NOTICE OF MEETING
PLANNING AND ZONING COMMISSION
6:00 P.M. – January 13, 2022

PLANNING AND ZONING COMMISSION ITEM:
PC-21-35
FINAL PLAT
Lux Tract Water Pumping Facility

PLANNING AND ZONING COMMISSION ITEM:
PC-21-36
REPLAT
Replat of Lot 69 & 70, Block 4, Belle Oaks Ranch
Phase I

SUBJECT: Lot 69 & 70 Replat Review
Belle Oaks Ranch Phase 1
PC-21-36

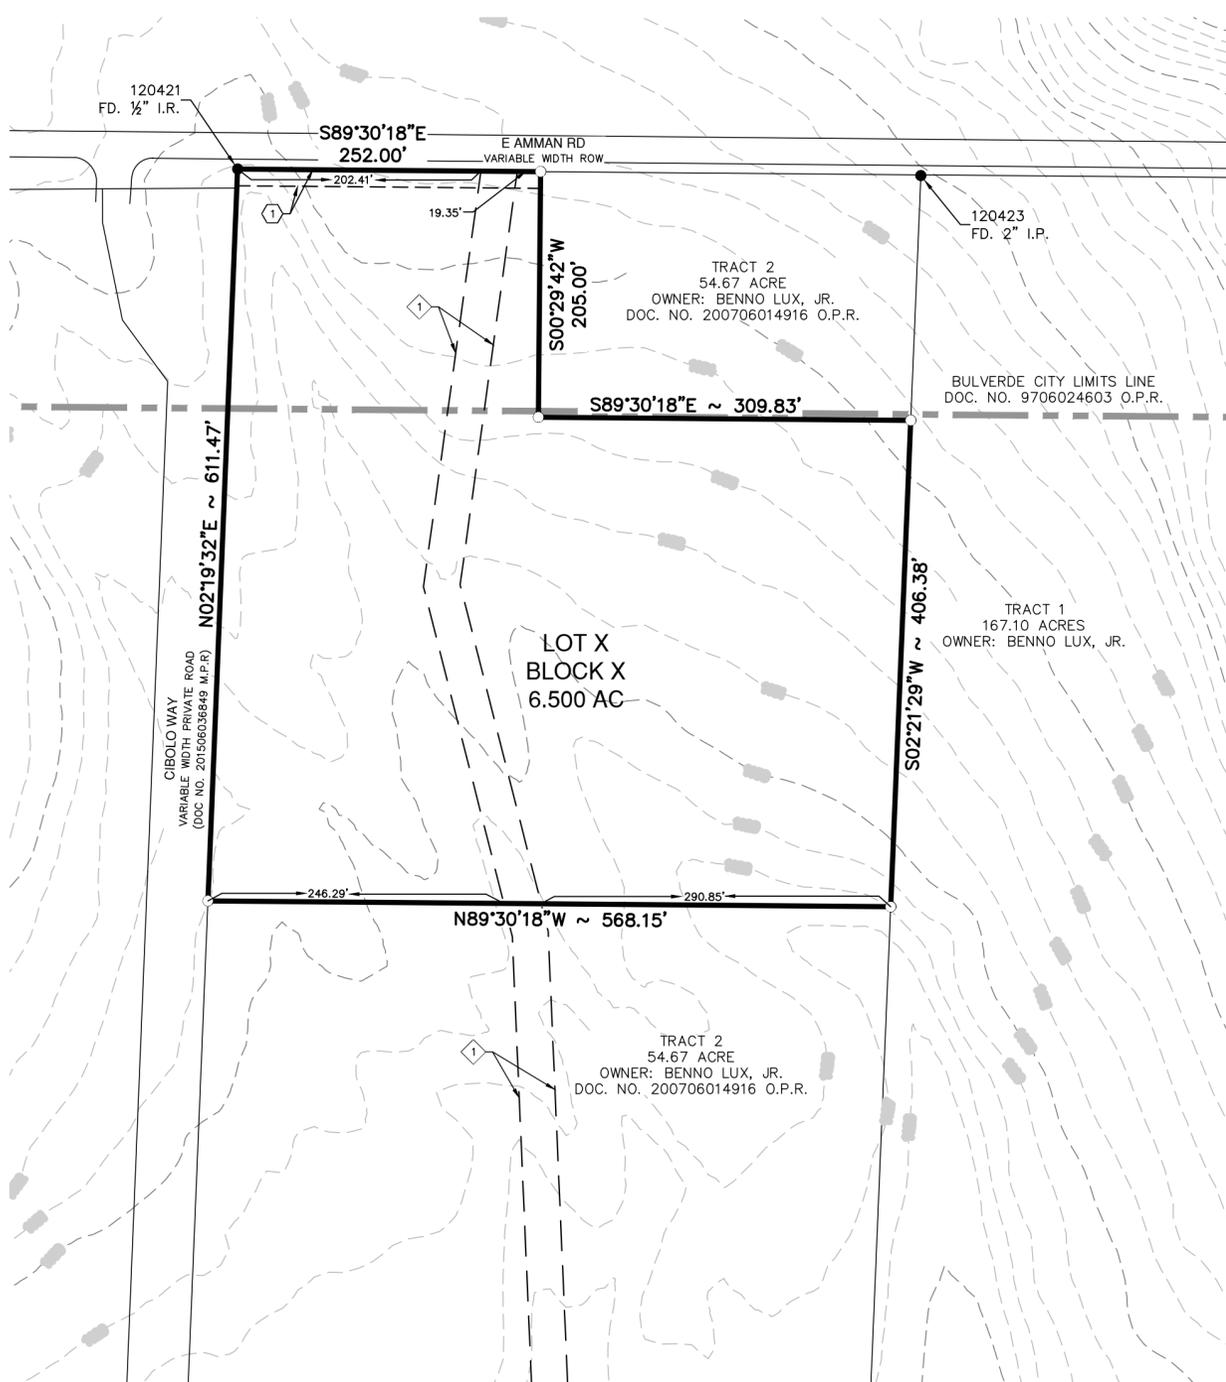
1. Use Lot 1, Block 1 (not Lot X, Block X)
2. Sheet 1 of X – additional sheets? If not, say “Sheet 1 of 1”
3. Missing setback lines
4. Contour labels not legible
5. A minimum of two corners of the subdivision referenced to State Plane Grid Coordinates.
6. Show City limits lines on vicinity map and plat
7. Bearing and distance dimension from a corner of the subdivision to a corner of the original tract or original survey.
8. Need to dedicate enough ROW to Amman Rd based on Comal County Major Thoroughfare Plan, Rural Collector with ultimate 120' ROW.

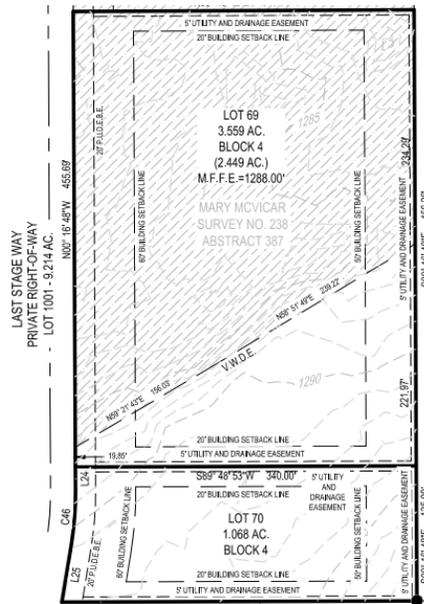
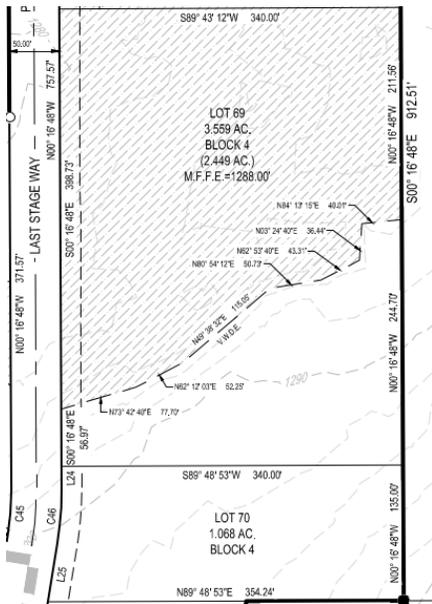
1. Revised plat name to include "Creating Lot 69R Block 4"
2. Date prepared needs to be updated with a specific date (MM/DD/YYYY).
3. Drainage easement does not match Phase 1 Final Plat, dated 5/10/2019, but the acreage matches:
